Alameda Grant Line Solar 1

Final EIR

for Alameda County

Figure 3-4
Groundmount Array Layout

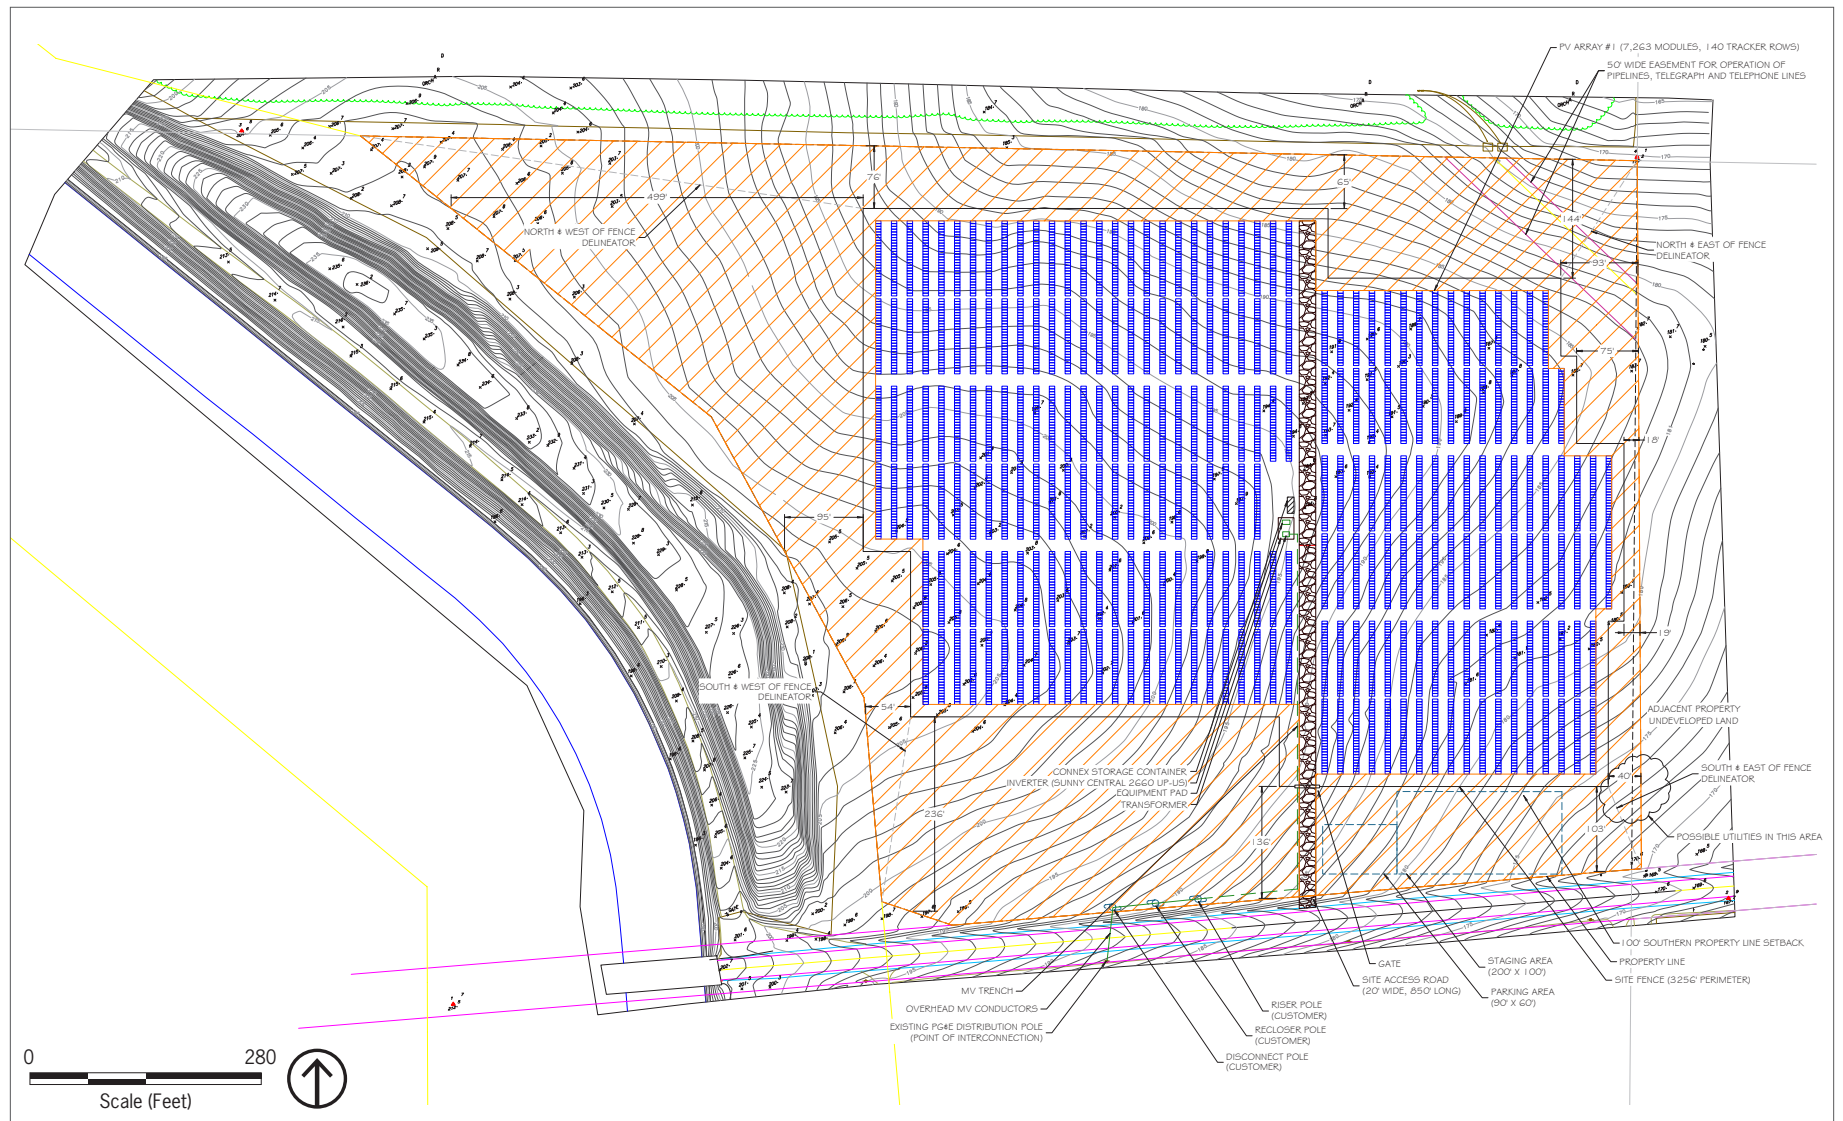
Figure 3-4, *Groundmount Array Layout*, is amended to show a revised site layout which shifts the solar arrays further east on the project site.
